NOTICE OF PROPOSED CHANGE IN PROPERTY

Petition: x339 ✓

PETITION NO. 339
OUR LADY OF THE ROSARY
5930 WOODWARD AVE.
DETROIT, MICHIGAN 48202
C/O FREDERICK M. ROTTACH
PHONE NO. 313 331-5611

REQUEST TO CONVERT TO EASEMENT
THE NORTH/SOUTH PUBLIC ALLEY
20 FT. WD. IN THE BLOCK BOUND BY
WOODWARD, HARPER AVE., JOHN R. ST.
AND EDSEL FORD FWY.

CITY OF DETROIT CITY ENGINEERING DEPARTMENT SURVEY BUREAU	
JOB NO.	01-01
DRWG. NO.	X 339

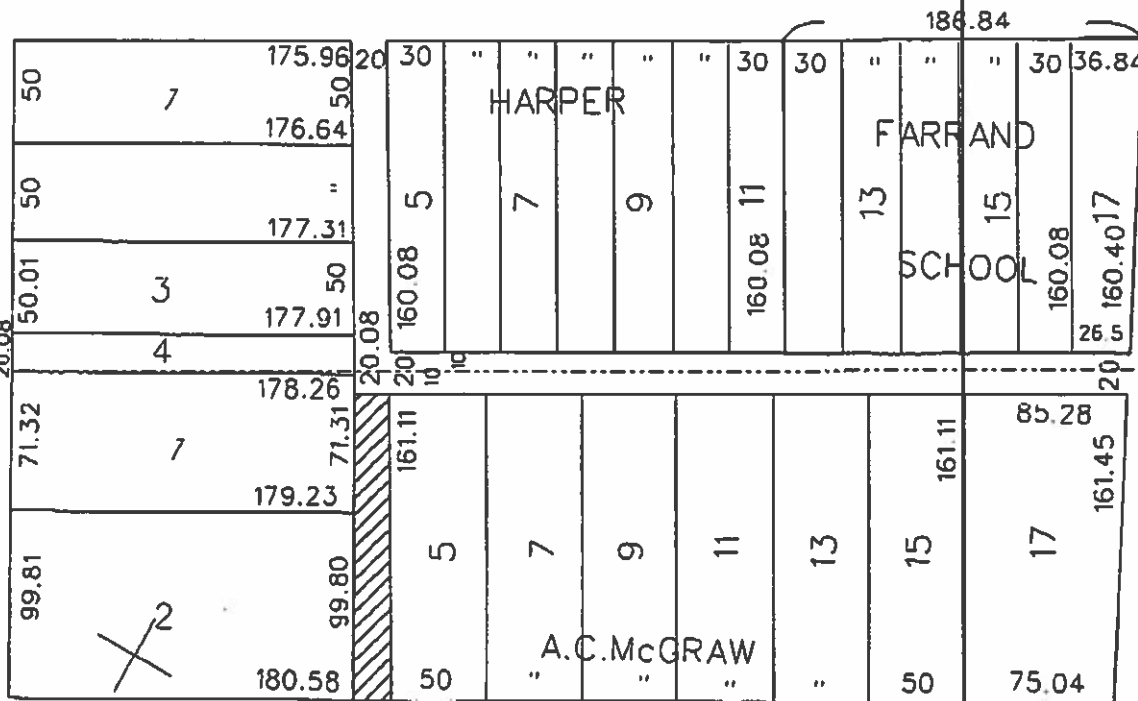
We request the petition be denied until petitioner clears alley to render a PLD cable pole and handhole accessible. Upon doing this and coordinating with Denise Williams on 313-267-7216, the petition is granted provided the full width of the public right-of-way is reserved.

Currently the alley is permanently blocked with various natural and man-made obstructions including a fence and a locked gate. We need 24-hour unimpeded heavy truck access to our facilities.
